**RE: Addendum No. 2
Canal Road Improvements from SR-161 to Wilson Blvd**

In response to questions and comments received by Thompson Engineering, Inc., and the City of Orange Beach, the plans, contract documents and specifications for the above referenced project are hereby revised as follows:

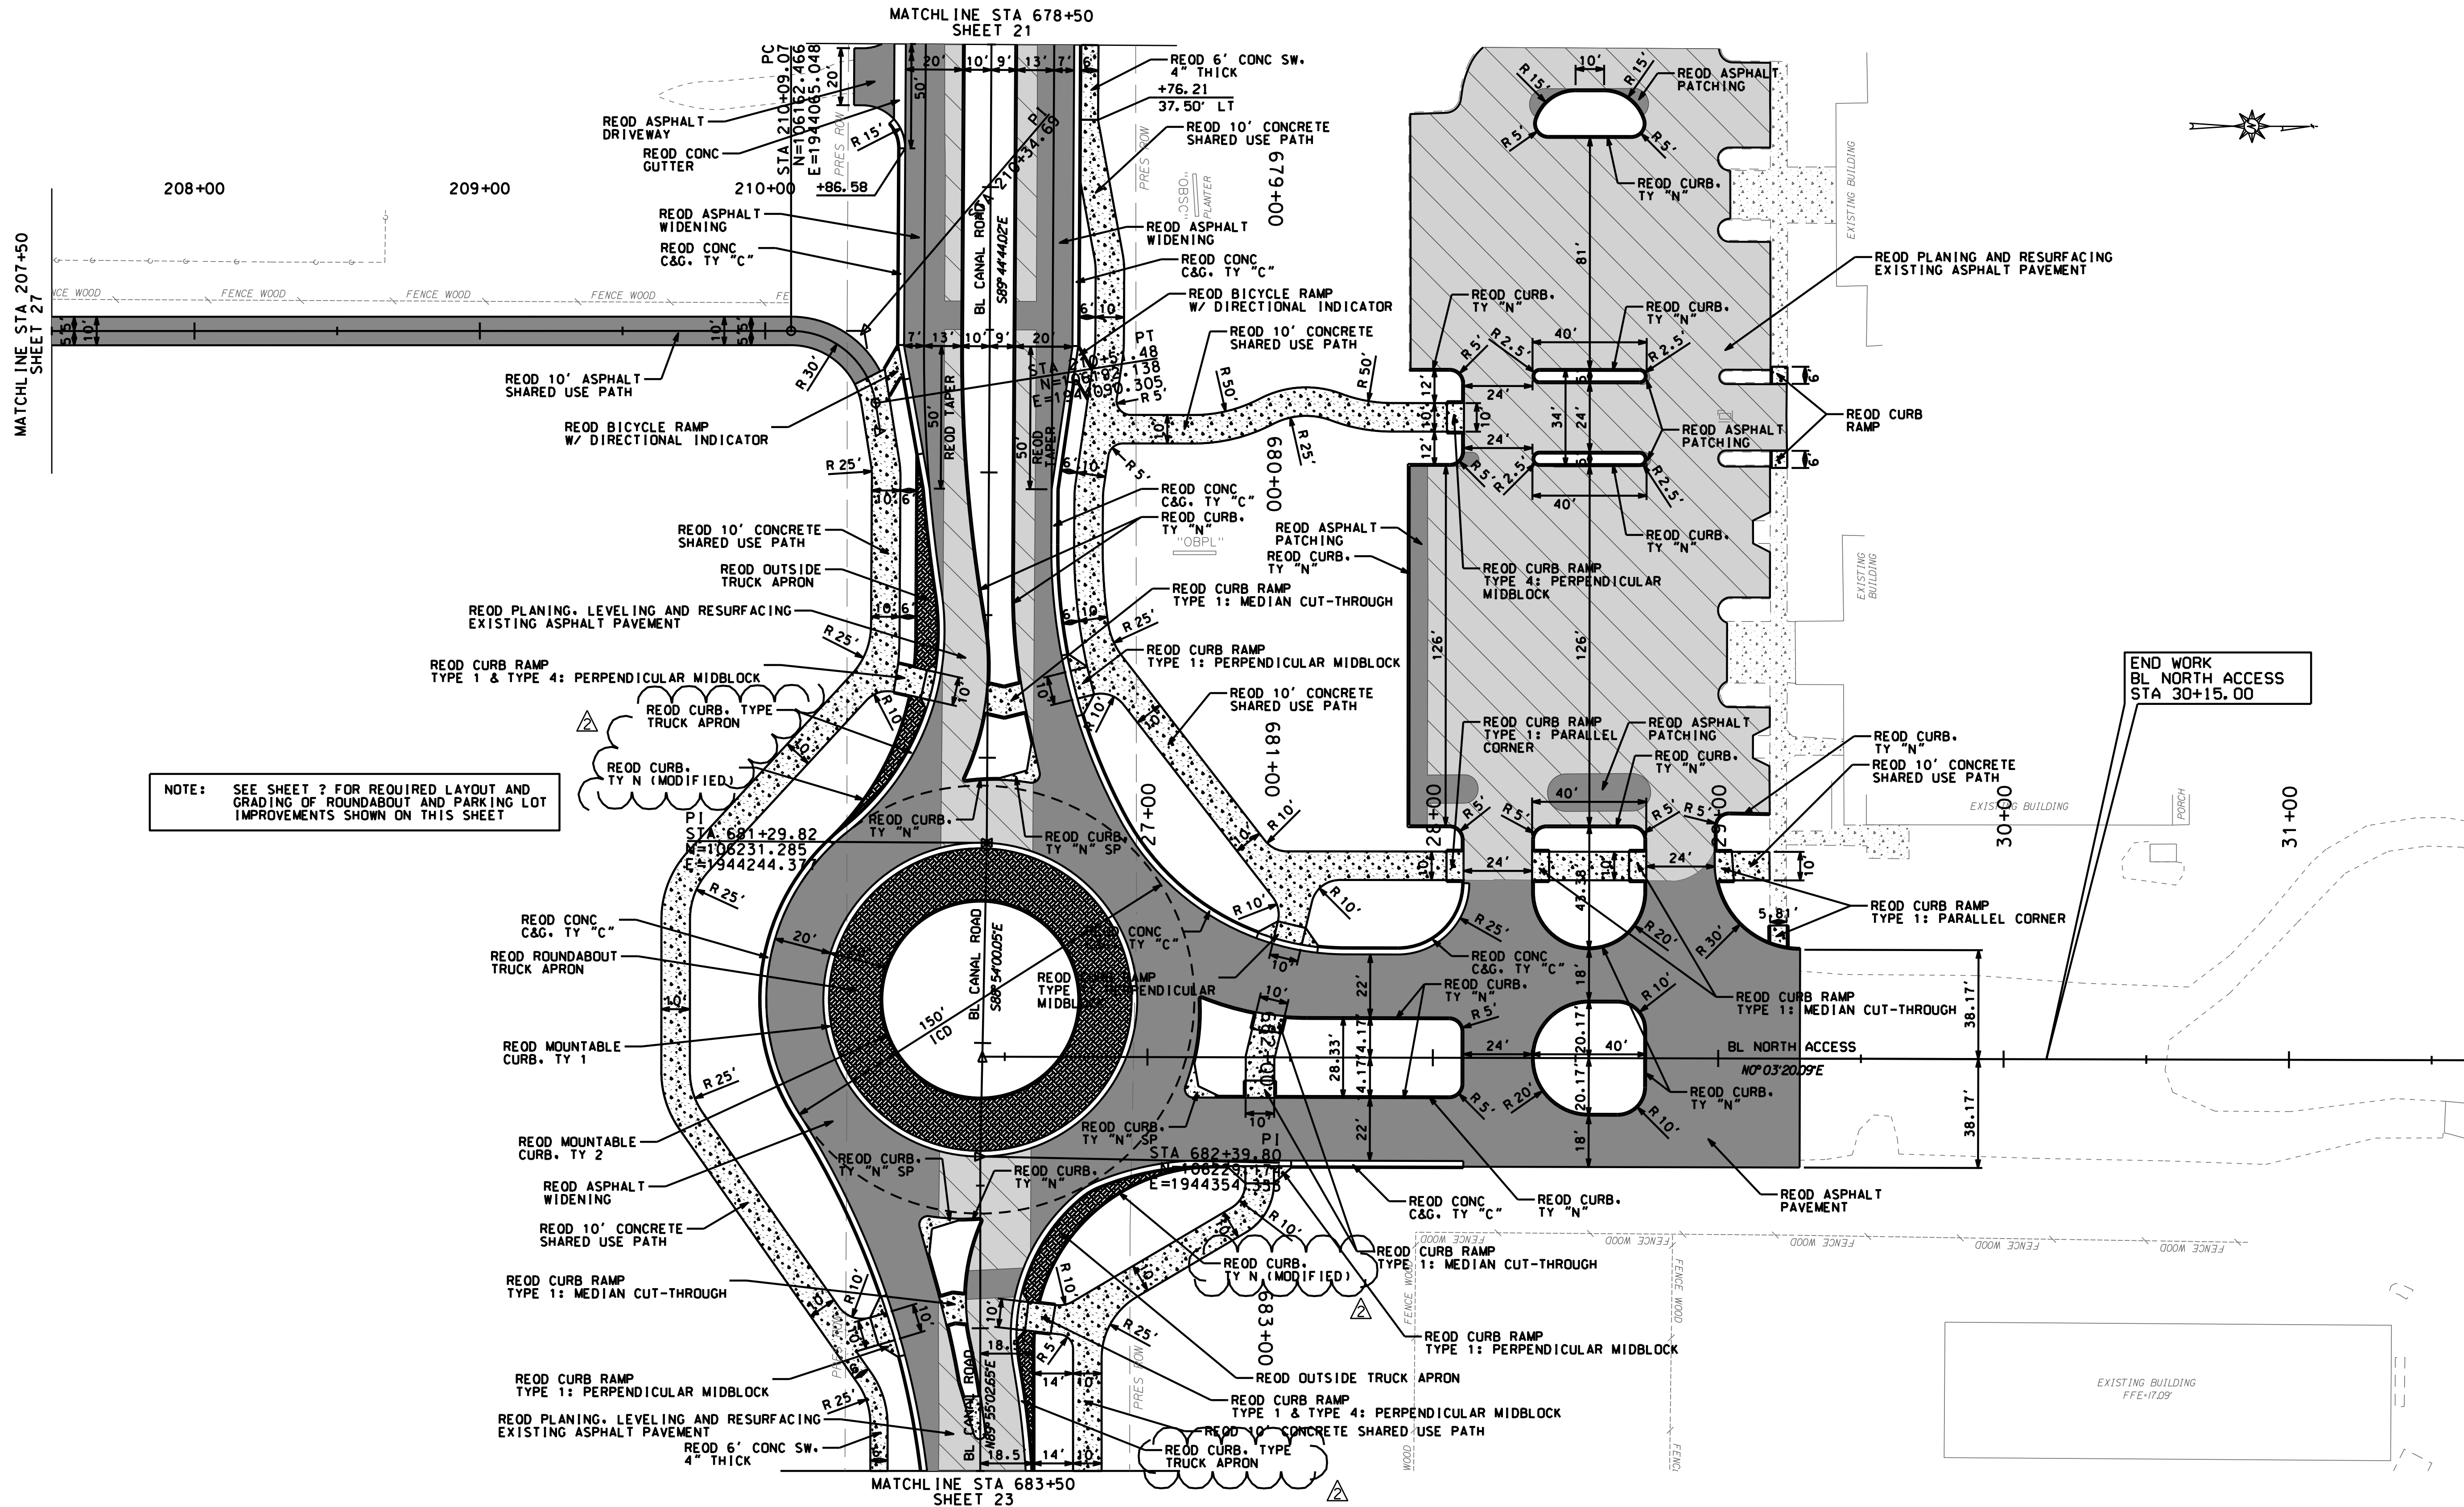
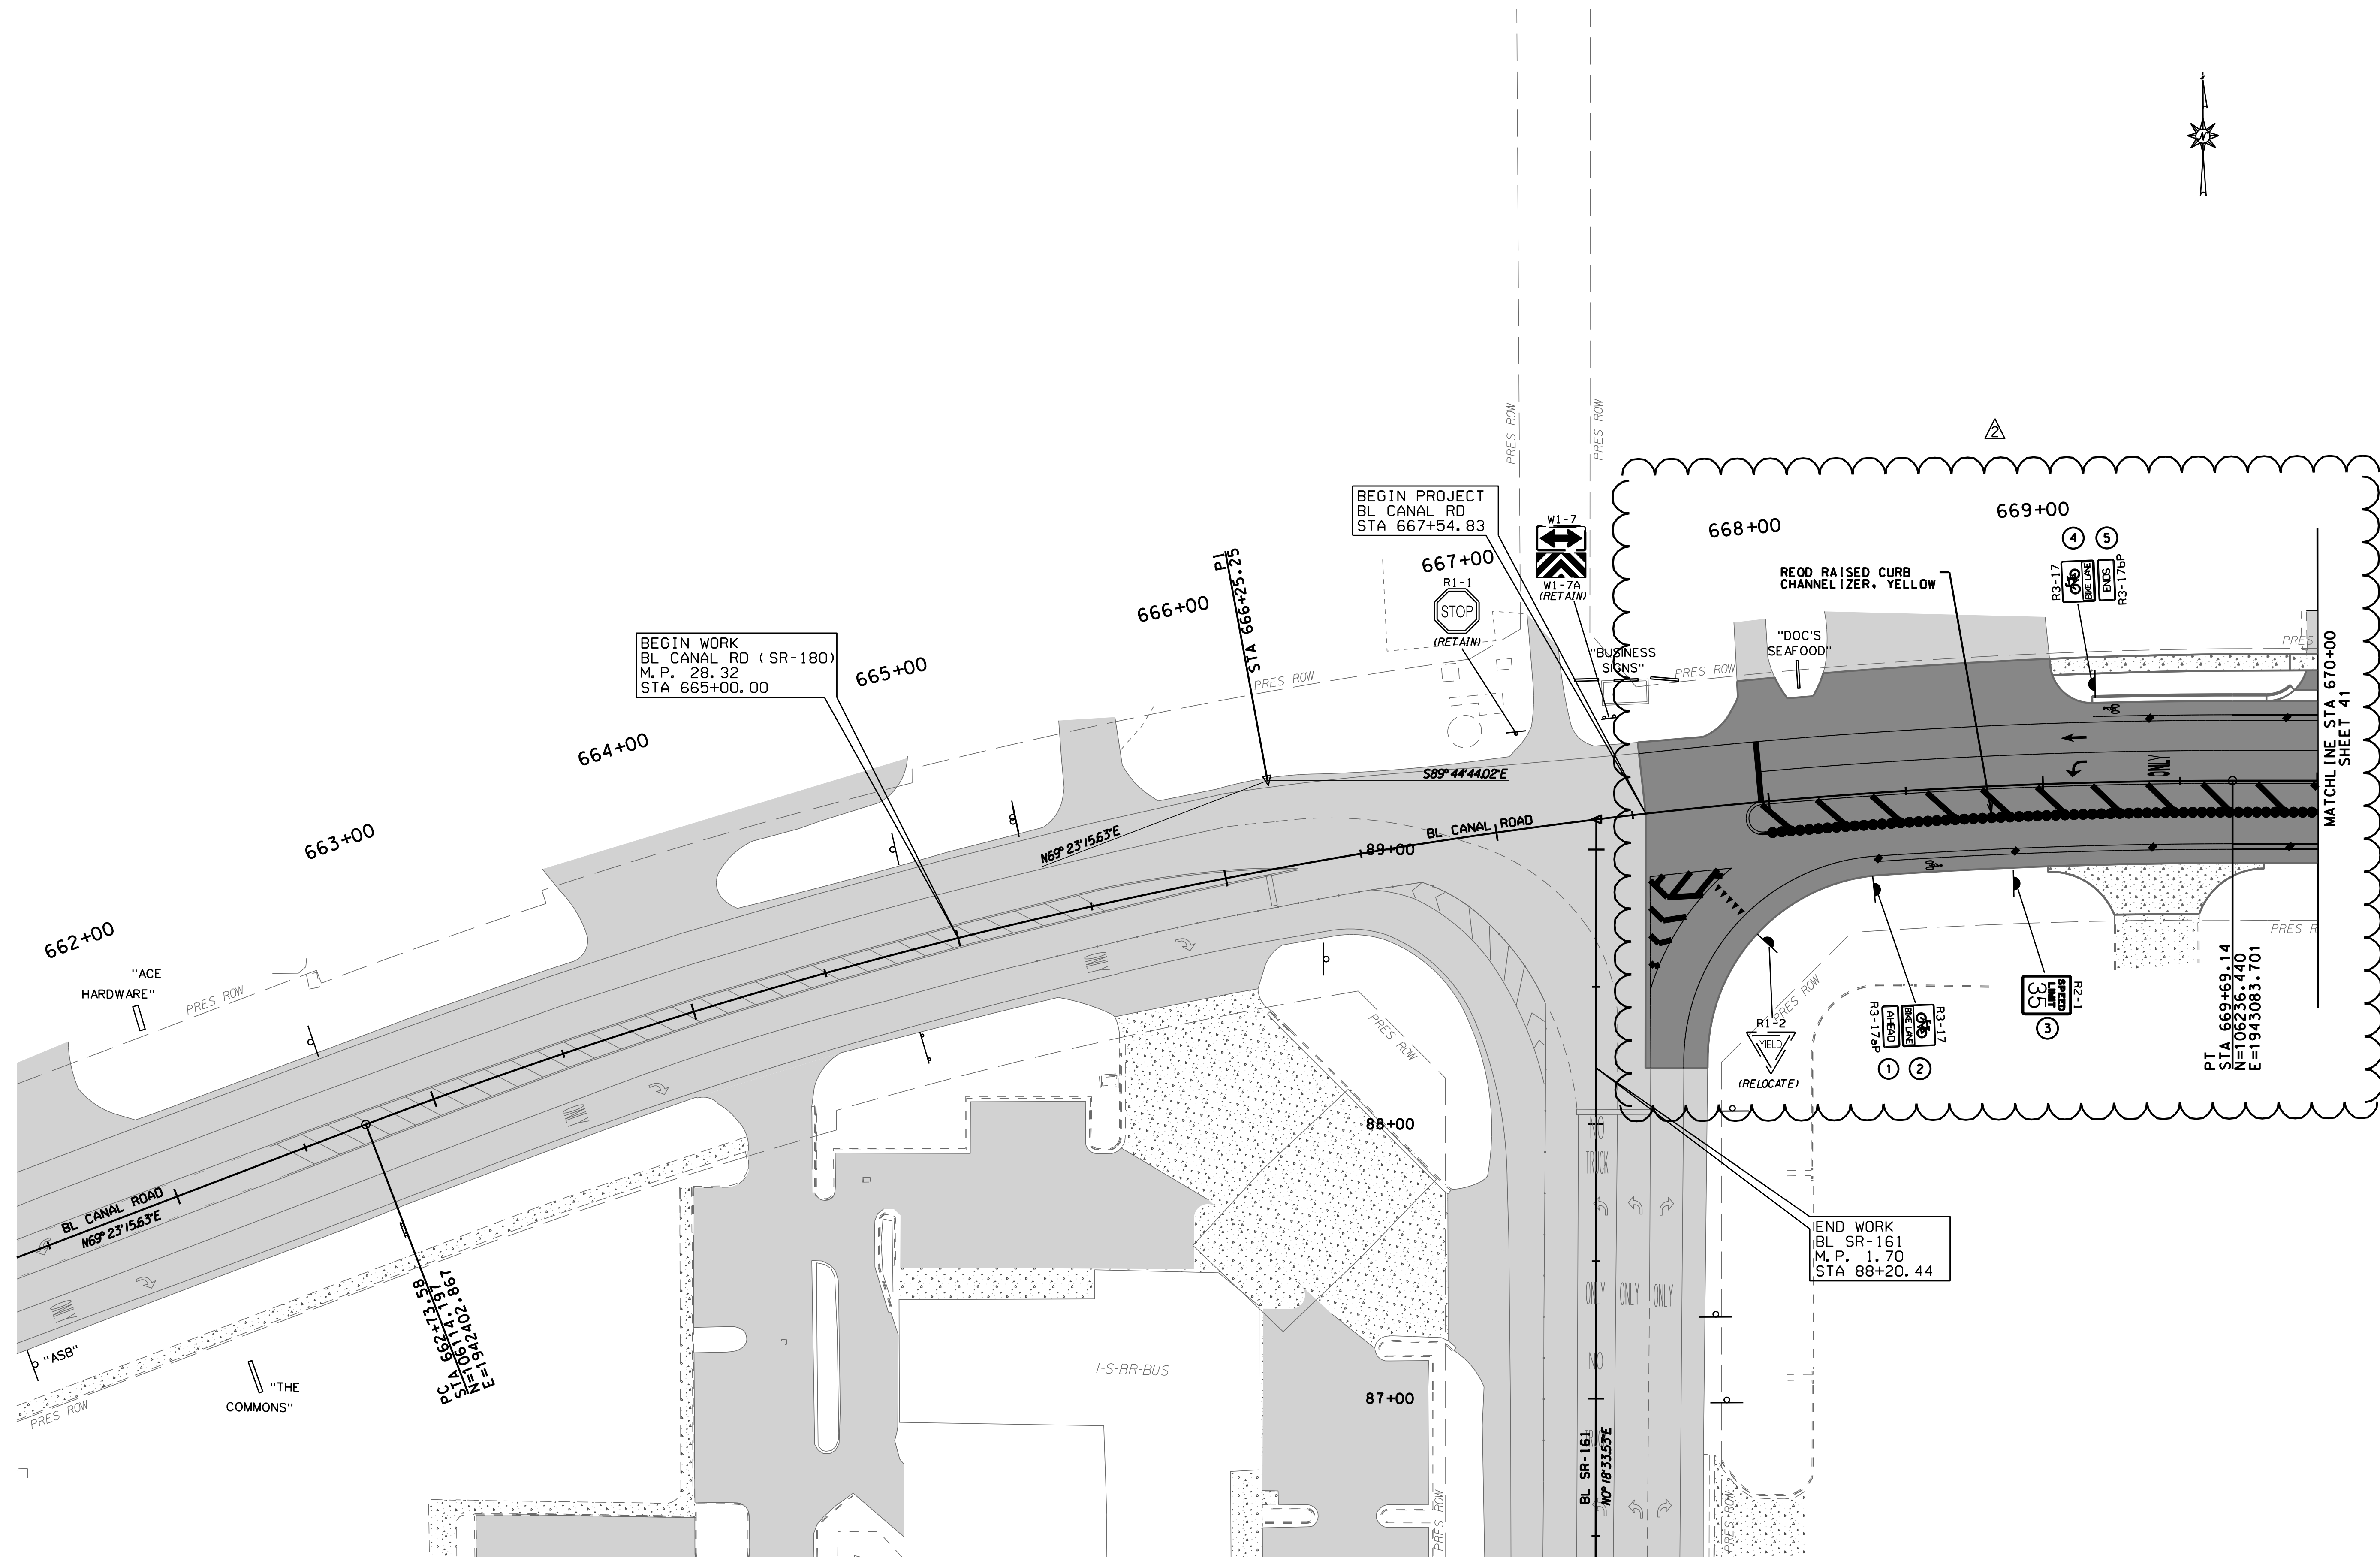
- V. On Sheet 3-D move summary box to new Sheet 3-I and add reference to the required Standard or Special Drawings in the summary box
 - VI. On Sheet 22, revise the callouts for the required curb to be used in truck aprons

SHEET NO. :	44
CANAL ROAD IMPROVEMENTS FROM SR-161 TO WILSON BOULEVARD	
SIGNING LAYOUT SHEET	
DATE :	DEC 2021
APPROVED BY :	
CHECKED BY :	
DRAWN BY :	
SCALE :	HORIZ 1"=30'
JOB NO. :	20-1101-0085
REVISION NO. :

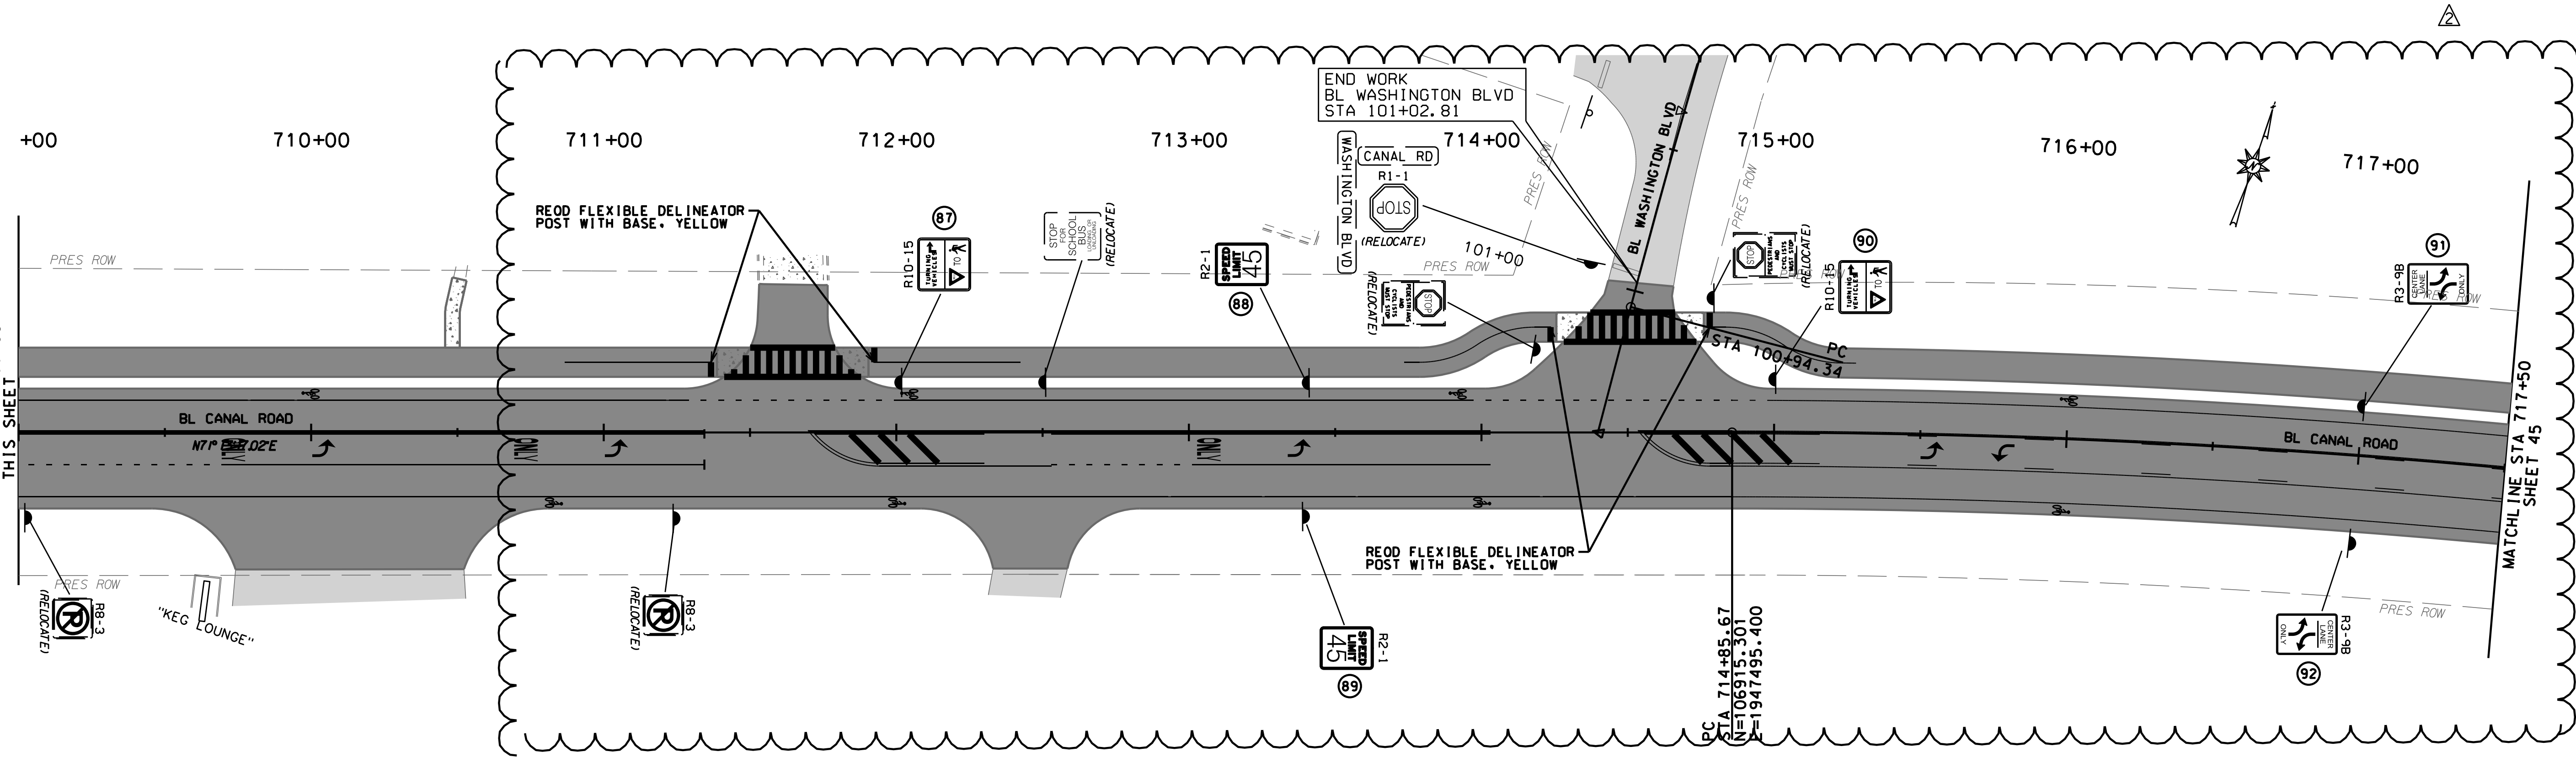
- VII. On Sheets 40 through 47, revise the signing plan as shown
 - VIII. Add the following sheets:
 - i. Sheets 2-K, 2-L, 2-M for additional typical sections
